Form 3160-5  
(June 2019)

SUNDRY NOTICES AND REPORTS ON WELLS  
Do not use this form for proposals to drill or to re-enter an abandoned well. Use Form 3160-3 (APD) for such proposals.

8. Well Name and No. ROSS DRAW 17 FED COM/802H

Ripple 32 Fed Com 737H (FKA Ross Draw 17 Fed Com 802H) API #: 30-015-48366

WELL LOCATION AND ACREAGE DEDICATION PLAT

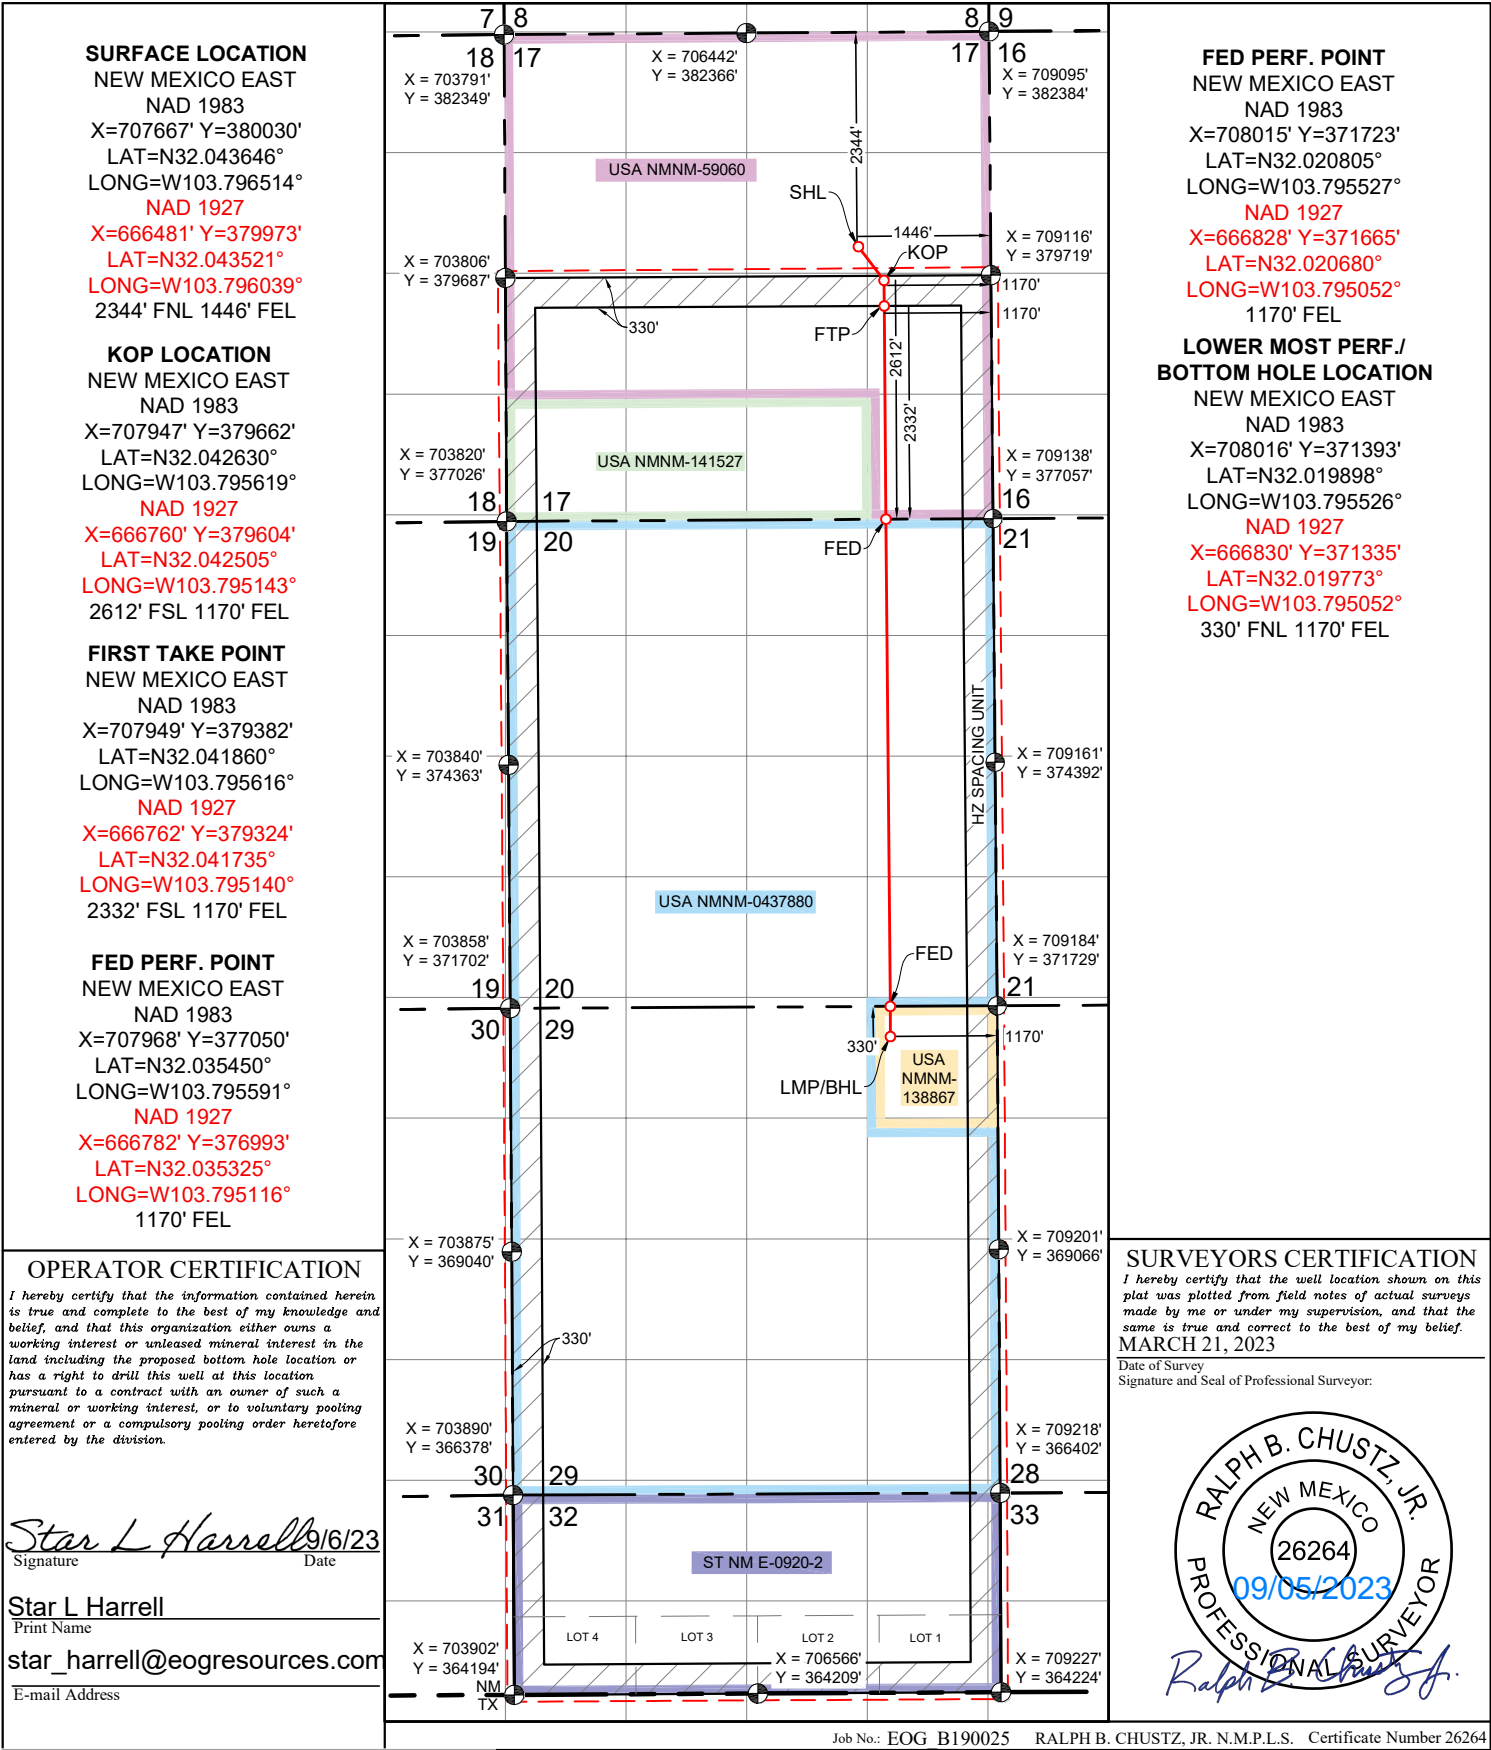
Change name from Ross Draw 17 Fed Com 802H to Ripple 32 Fed Com 737H.

Change BHL from T-26-S, R-31-E, Sec 8, 230' FNL, 1650' FEL, Eddy Co., NM, to T-26-S, R-31-E, Sec 29, 330' FNL, 1170' FEL, Eddy Co., N.M.

Change target formation to Wolfcamp U2.

Update HSU to 1862 acres.

UL or lot no. A	Section 29	Township 26 S	Range 31 E	Lot Idn	Feet from the 330	North/South line NORTH	Feet from the 1170	East/West line EAST	County EDDY
--------------------	---------------	------------------	---------------	---------	----------------------	---------------------------	-----------------------	------------------------	----------------

Dedicated Acres 1862	Joint or Infill	Consolidated Code	Order No. PENDING NSP & PENDING COM AGREEMENT
-------------------------	-----------------	-------------------	--
